IEC
60335-2-35

AMENDMENT 1
2006-10

Amendment 1

Part 2-35: Particular requirements for instantaneous water heaters

Figure 103 – Diagram for the leakage current measurement for single-phase bare-element water heaters supplied by a supply cord fitted with a plug

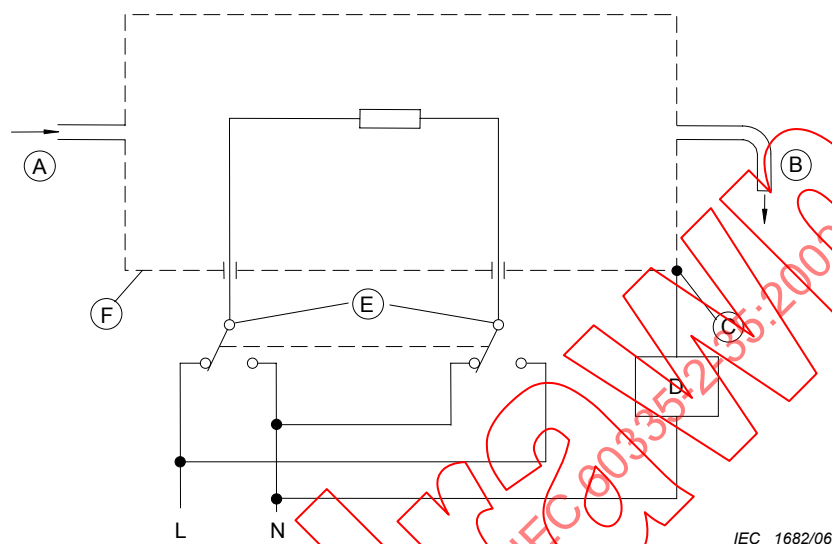
For **bare-element water heaters** intended to be connected to the power supply by a **supply cord** fitted with a plug, the leakage current test is repeated. During this test, the leakage current is measured between the earthing terminal of the appliance and the neutral conductor, as shown in Figure 103. The leakage current, measured with the selector switch in each position, shall not exceed 2,75 mA.

Add the following new figure:
